Stage 1 Road Safety Audit.  
Church Street Junction Improvements,  
Athlone.

Report

Job No. ST17466

Date 07 November 2016

JUNCTION 1 - COOSAN POINT ROAD / NORTHGATE STREET

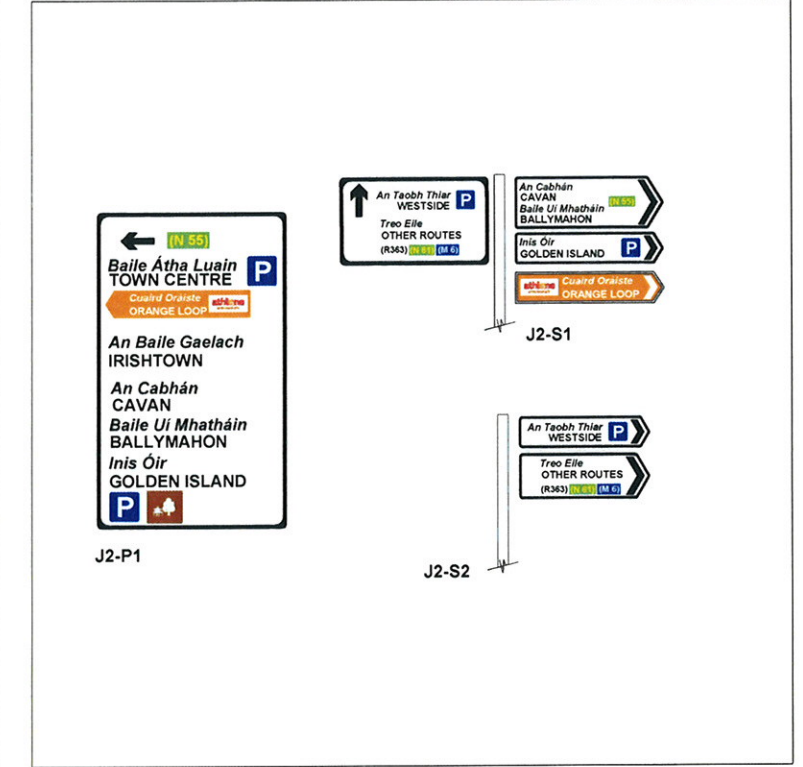
Location: 26 – Signs J1-P1, J1-P2 and J1 P3.

Summary: Lack of space and restricted visibility to signage, risk of signage being missed, increased risk of sudden late movements and increased risk of collisions.

The proposed locations of all the above signs have problems will lack of space to provide the sign and also problems with the visibility to the signage. A lack of space for the signage will increase the risk of the signage being struck by a high sided vehicle. A lack of visibility to the sign will increase the risk of drivers missing the information on the sign and undertaking late sudden movements at the junction increasing the risk of causing a collision at the junction.

It is recommended that the locations of all the signage is reviewed to ensure the proposed locations are adequate in terms of space for the sign to be provided and also adequate forward visibility is provided to the sign to allow approaching drivers the time to take in the signs message.

JUNCTION 2 - CUSTUME PLACE /CHURCH STREET JUNCTION

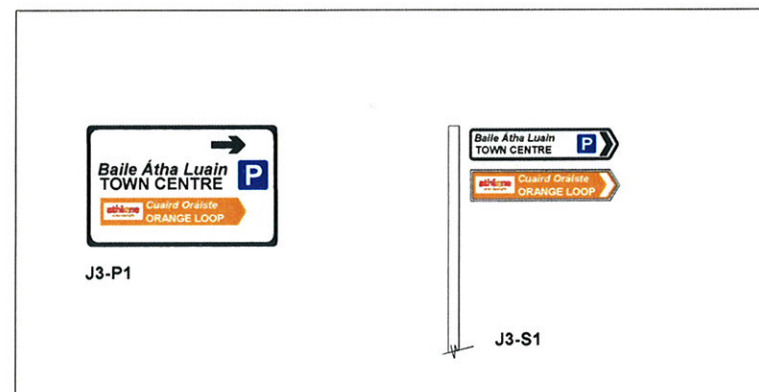
3.14 **Problem:**  
Location: 14 – Signage J2-P1 on Custume Place.

Summary: Narrow footway with insufficient space to provide sign posts or sign face whilst maintain clearance to the carriageway, increased risk to pedestrians being struck and/or signage being struck by vehicles.

The proposed location of sign J2-P1 is on the footway of the existing bridge where the footway is narrow and the signage would have to have special mounting posts to allow it to overhang the side of the bridge to move to sign away from the carriageway edge. If standard sign posts are provided within the footway then these may obstruct the footway, due to the size of the posts required to hold the proposed sign. Adequate clearance to the sign might not then be provided increasing the risk of pedestrians being struck if they walk within the carriageway around the sign posts or the sign face being struck by a large vehicle.

It is recommended that the sign posts are designed to ensure that they do not obstruct the footway over the bridge and the sign face can overhang the side of the bridge to ensure sufficient lateral clearance to the edge of the carriageway is provided.

JUNCTION 3 - PUMP LANE / MARDYKE STREET

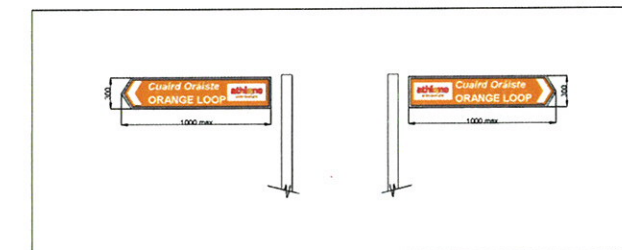
Location: 2 – Signage J3-P1 on Mary's Place.

Summary: Narrow footway, insufficient space to provide signage and maintain clearance to the carriageway, increased risk of signage being struck by large vehicles.

At the proposed location of the sign the footway is narrow and buildings abut the back of the footway preventing the signage being moved away from the carriageway. Due to the size of the proposed signage it does not look possible to provide the signage in the location shown without overhanging the carriageway increasing the risk of the signage being struck by a large vehicle. The size of the sign would also require two posts, which will also block the narrow footway which may force pedestrians to step into the carriageway to avoid the sign posts and increasing the risk of being struck by a vehicle.

It is recommended that the location of the signage is moved further northwards on Mary's Place to the end of the building line where additional space is available to provide the signage whilst maintaining sufficient lateral clearance to the edge of the carriageway. The sign posts should also be positioned so they do not obstruct the footway.

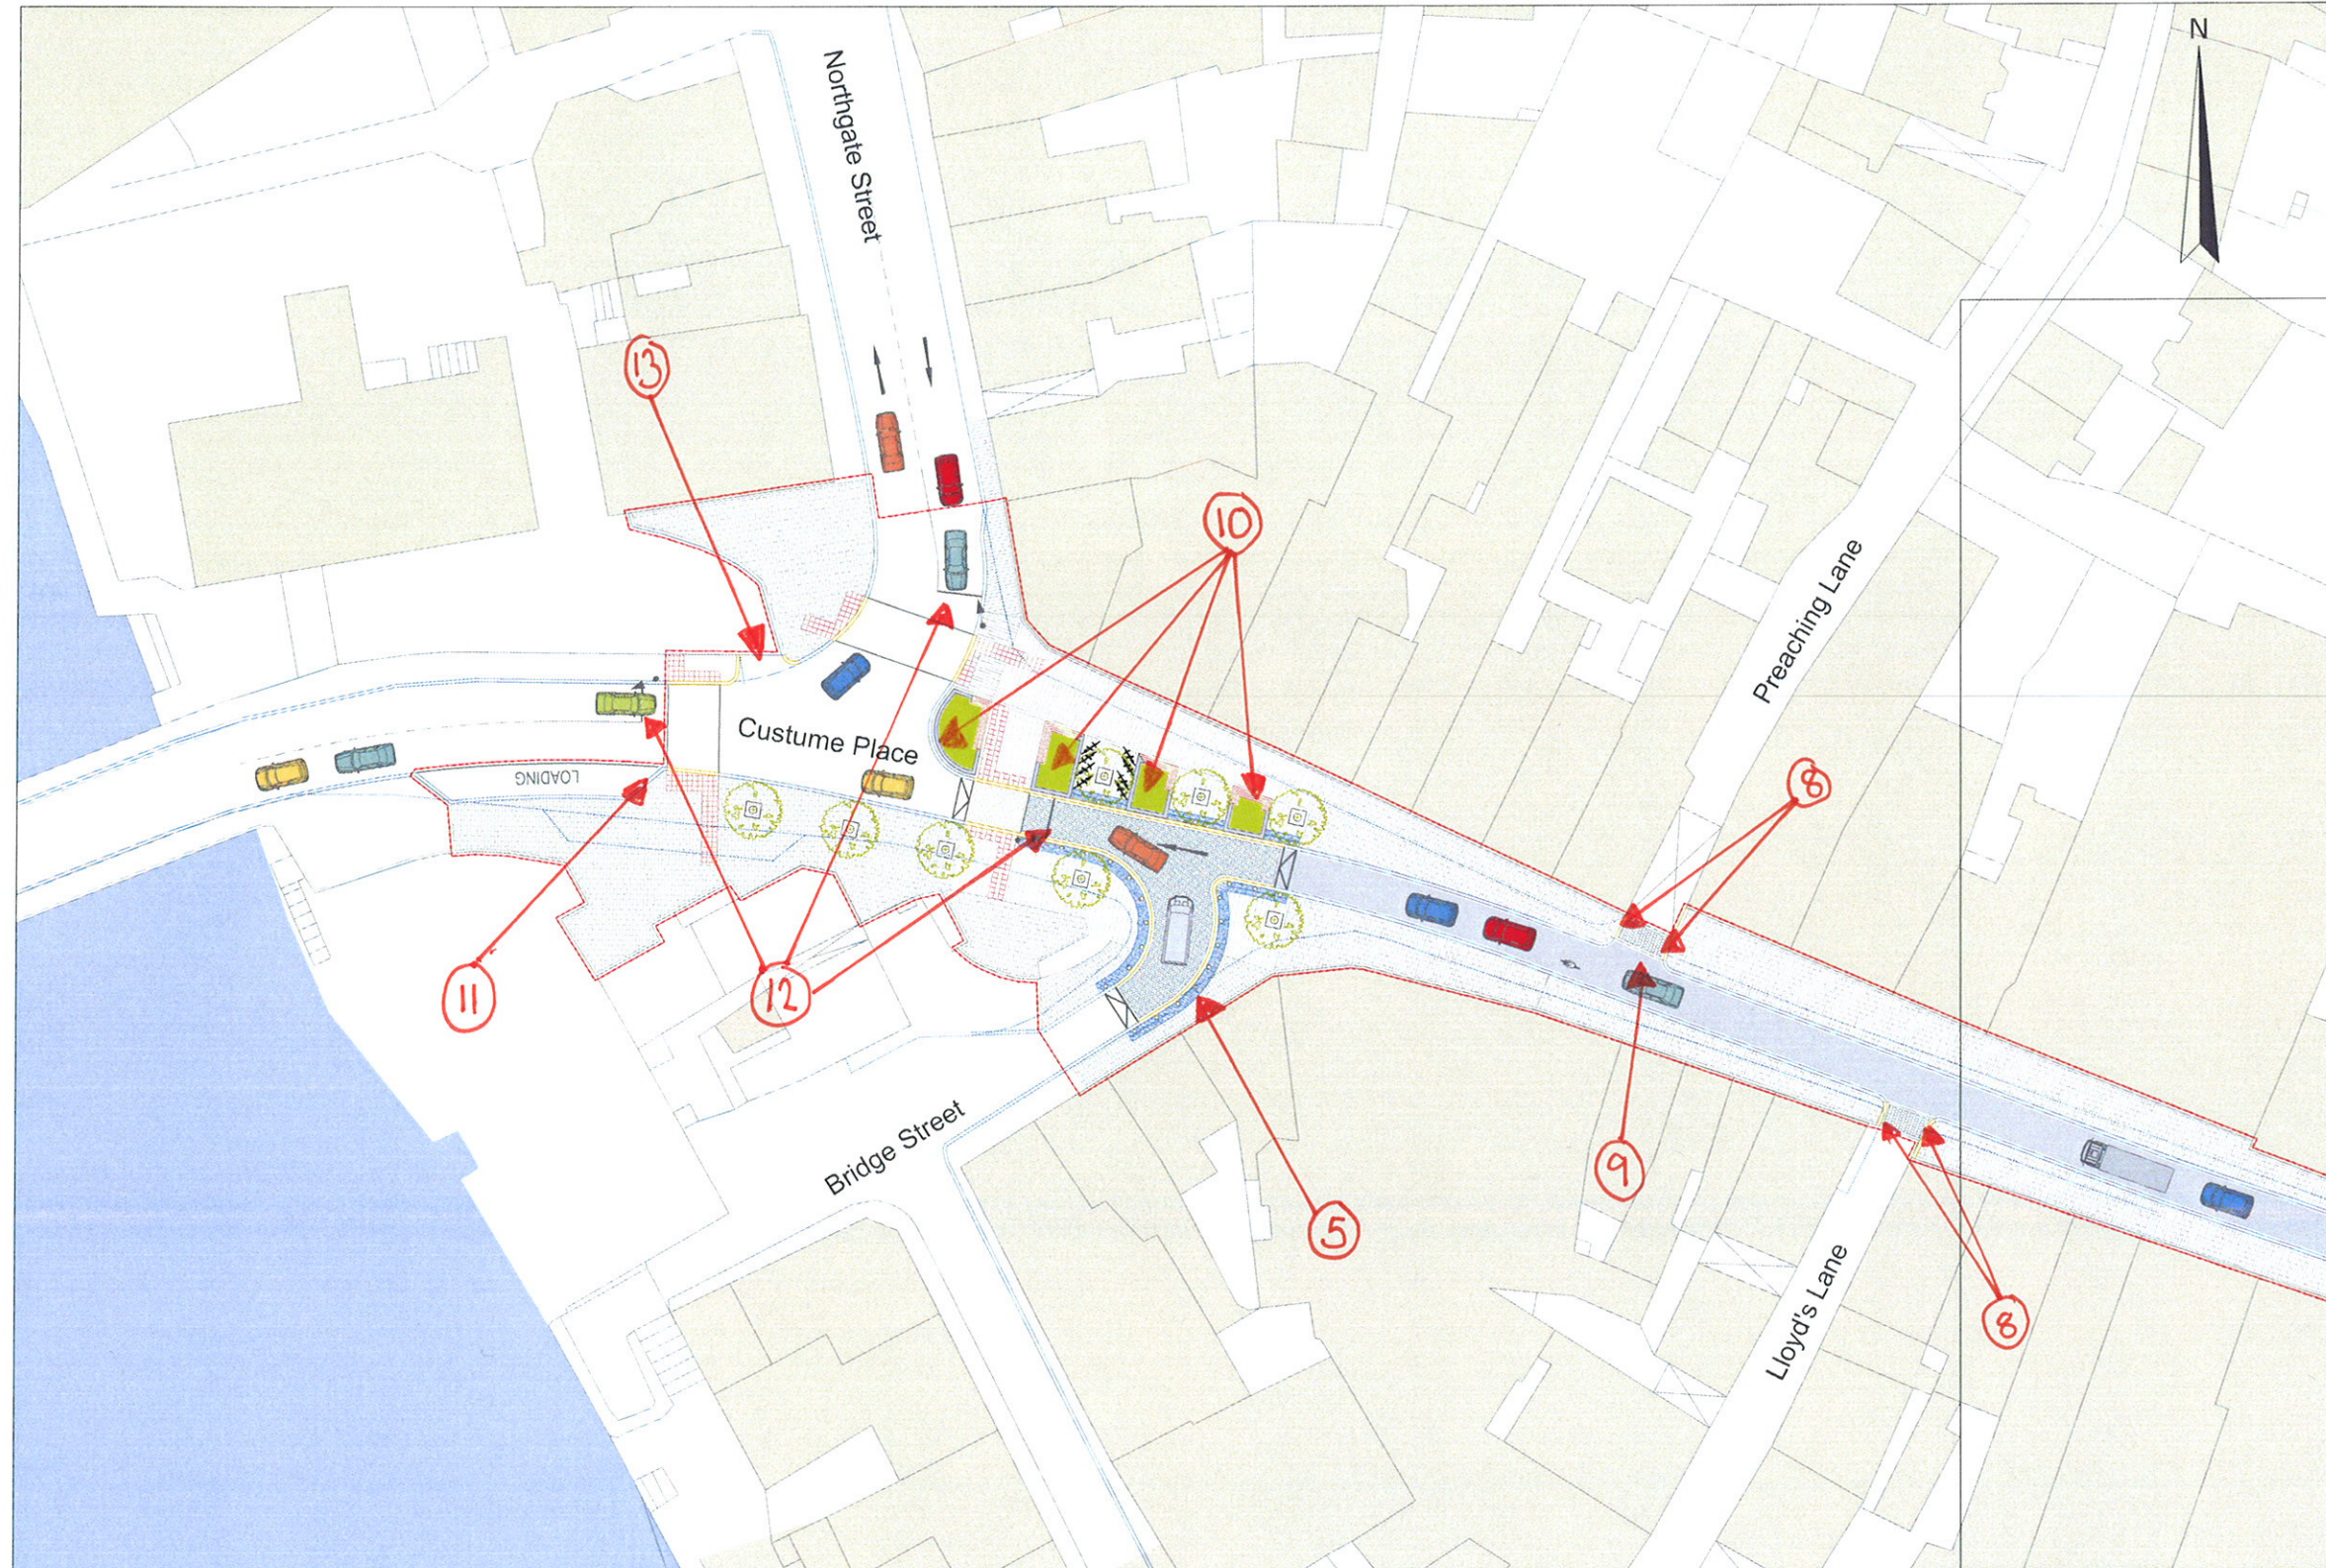
Location: 12 – All stop lines at the junction.

Summary: Only 2m provided between stop lines and stud markings, risk of pedestrians on crossing being within the blind spot of large vehicles and being struck.

The drawings show the distance between the stop lines at the junction and the stud markings of the pedestrian crossings is only 2m. Large vehicles have a blind spot in front of them due to the height of the driver position and if a large vehicle is stopped at the stop line a pedestrian using the crossing could be hidden from view and within this blind spot. This will increase the risk of a pedestrian using the crossing from being struck by a large vehicle.

- 3.19 **Problem:**  
 Location: 19 – Stop lines on Northgate Street.
- Summary: Only 2m provided between stop line and stud markings, risk of pedestrians on crossing being within the blind spot of large vehicles and being struck.

- The drawings show the distance between the stop line at the junction and the stud markings of the pedestrian crossing is only 2m. Large vehicles have a blind spot in front of them due to the height of the driver position and if a large vehicle is stopped at the stop line a pedestrian using the crossing could be hidden from view and within this blind spot. This will increase the risk of a pedestrian using the crossing from being struck by a large vehicle.

Location: 20 – Eastern pedestrian crossing on Northgate Street.

Summary: Visibility splay to pedestrian obstructed by stone wall, risk of pedestrian being struck by a vehicle approaching from South Station Road.

The visibility splay from the eastern side of the pedestrian crossing on Northgate Street passes behind the existing stone wall that runs around the eastern side of Northgate Street and into Southern Station Road. A lack of visibility between pedestrians and drivers approaching this crossing will increase the risk of a pedestrian attempting to use the crossing and being struck by a vehicle.

Location: 21 – Coosan Point Road and South Station Road.

Summary: Obstruction to primary signal head, increased risk of vehicles overshooting the junction and causing a collision with other road users.

The visibility to the primary signal head from both the Coosan Point Road and South Station Road approaches to the junction are obstructed by overgrown vegetation and mature trees. If drivers cannot see the primary signal head on the approach to the junction this will increase the risk of vehicles overshooting the stop lines increasing the risk of causing a collision with other road users.

- 3.23 **Problem:**  
Location: 23 – Central area of junction.
- Summary: Lack of guidance road markings for right turning vehicles, increased risk of head on collisions in the central area of junction.

- No road markings have been provided within the central area of the junction to prevent right turning vehicles from Northgate Street encroaching into the vehicle path of vehicles travelling southwards from Coosan Point Road. A lack of guidance for right turning vehicles will increase the risk of head on and side swipe collisions within the central area of the junction.

Location: 25 – Coosan Point Road to Southern Station Road.

Summary: Tight left turn risk of over running footway and/or collisions with vehicles waiting at stop line on Southern Station Road.

The turn from Coosan Point Road to Southern Station Road is very tight and will be difficult for large vehicles to undertake without either over running the footway or the stop line of South Station Road. This will increase the risk to pedestrians using the footway and of collisions between turning vehicles and waiting vehicles on Southern Station Road.

It is recommended that the distance between the stud markings and the stop lines at the junction are all increased to a minimum distance of 3m.

It is recommended that the distance between the stud markings and the stop line is increased to a minimum distance of 3m.

It is recommended that the existing stone wall is removed and any other obstructions within the visibility splay are also removed to provide unobstructed visibility between drivers and pedestrians at the junction.

It is recommended that the existing trees and overgrown vegetation are removed to provide clear unobstructed forward visibility to the primary signal heads. An additional off-side primary signal head could also be provided on both approaches which would improve the visibility to the junction if the existing trees cannot be removed for environmental reasons.

- Recommendation:
- It is recommended that some guidance road markings are provided within the central area of the junction to indicate where right turning vehicles should wait to enter Southern Station Road.

It is recommended that the swept path of all large vehicles that are anticipated to be undertaking this movement to be checked to ensure that they do not over run the footway or the stop line and if necessary the stop line on Southern Station Road and Coosan Point Road be set back to allow the movement to be undertaken safely.
